Work Order ID 138542

Item ID: D4864-1 Accept *N900040100* Setup Start *NS1*
Revision ID: Stop *NS2*
Item Name: RHeostat
Start Date: 11/2/2015 Start Qty: 8.00 *8* Cust Item ID:
Required Date: 11/13/2015 Req'd Qty: 8.00 *8* Customer:
Reference: REWORK RHEOSTATE AS PER DRAWING

D4864-X RHEOSTAT

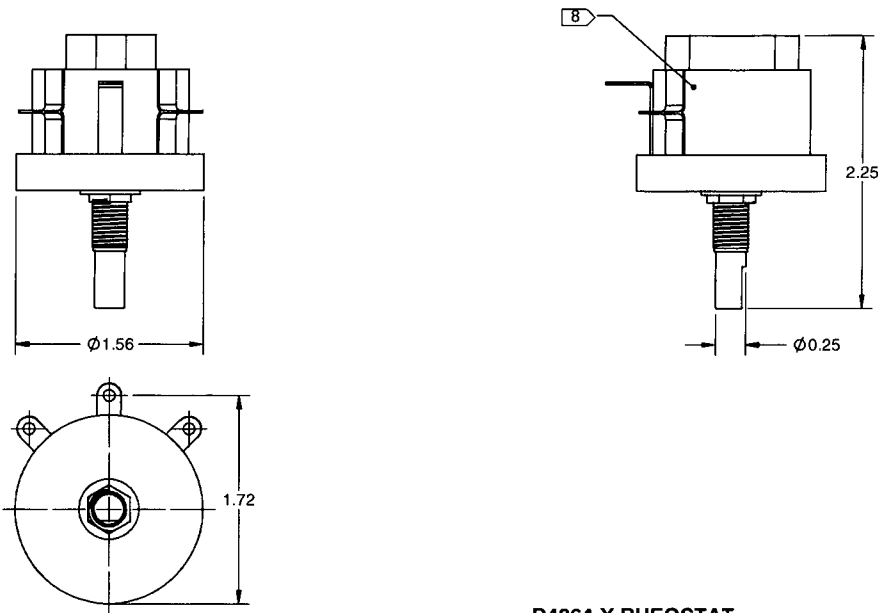
PULL FROM STOCK
D4864-1 X8
B: 128026TO REWORK AS PER DRAWING
GRIND AND CUT 1 TO 2 WIRES AND APPLY PROTECTIVE COATING.

SEE PICTURE FOR CORRECT SIDE

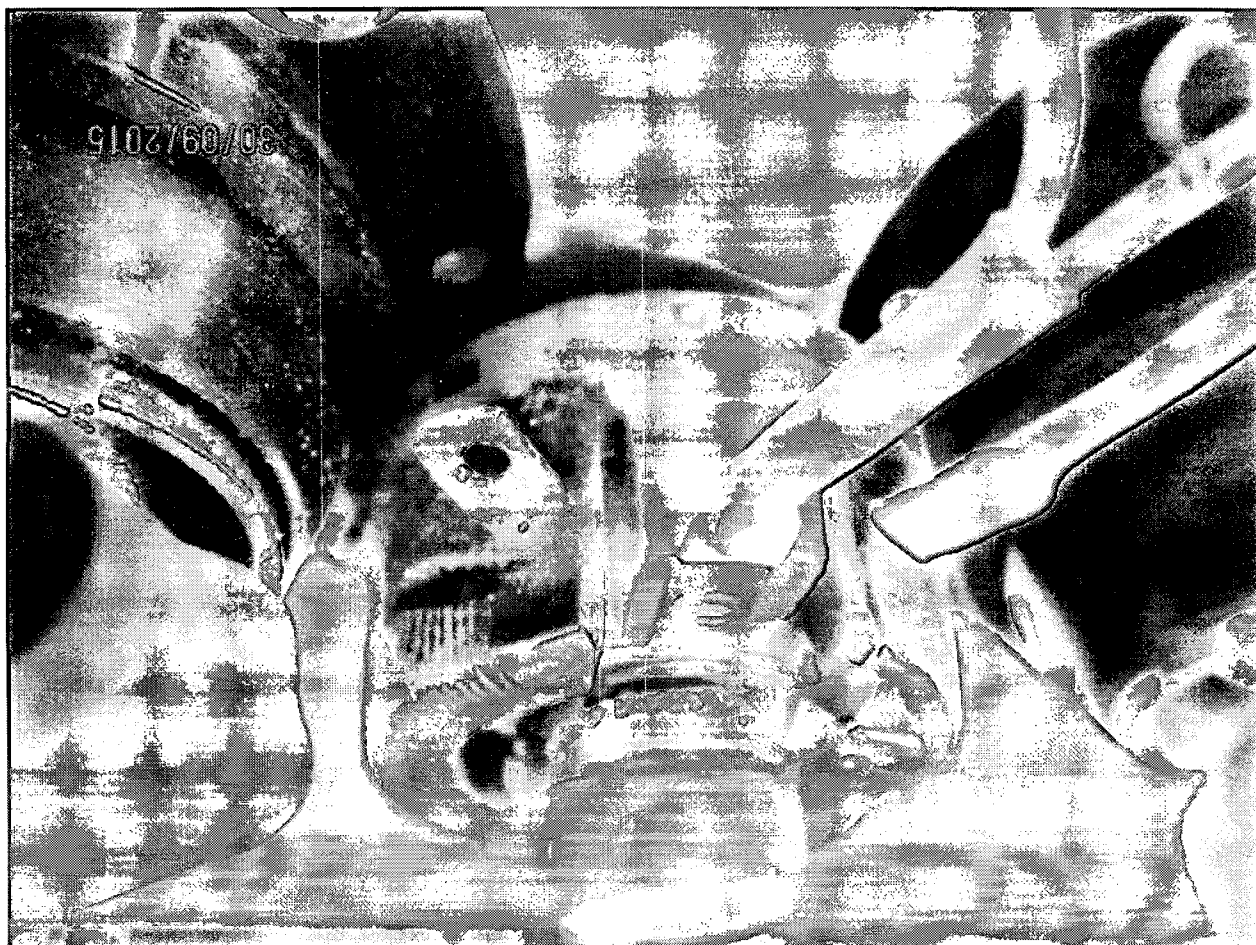
PB1	REVISE VENDOR AND VENDOR PART NUMBER, ADD NOTE 8	VS	13.10.07
A	NEW ISSUE	OS	13.06.21
REV.	DESCRIPTION	BY	DATE
DESIGN	OS	DART AEROSPACE USA, INC. KENT, WA	
DRAWN	OS		
CHECKED	EC	DRAWING NO.	REV. PB1
MFG. APPR.		D4864	SHEET 1 OF 1
APPROVED		TITLE	SCALE
DE APPR.		RHEOSTAT	NTS
DATE	13.10.07	COPYRIGHT © 2013 BY DART AEROSPACE USA, INC. THIS DOCUMENT IS PRIVATE AND CONFIDENTIAL AND IS SUPPLIED ON THE EXPRESS CONDITION THAT IT IS NOT TO BE USED FOR ANY PURPOSE OR COPIED OR COMMUNICATED TO ANY OTHER PERSON WITHOUT WRITTEN PERMISSION FROM DART AEROSPACE USA, INC.

- 1) MATERIAL: PER TABLE
- 2) FINISH: NONE
- 3) TOLERANCES: PER DART QSI 018 UNLESS OTHERWISE NOTED
- 4) UNITS: INCHES UNLESS OTHERWISE NOTED
- 5) BREAK SHARP EDGES: 0.005 TO 0.010 MAX
- 6) IDENTIFICATION: IDENTIFY PER QSI 044 6.7
- 7) WEIGHT: PER TABLE
- 8) GRIND THRU ONE TO FOUR WIRES AND APPLY PROTECTIVE COATING OF ACRYLIC ENAMEL TO PROVIDE FULL OFF IN THE "OFF" POSITION
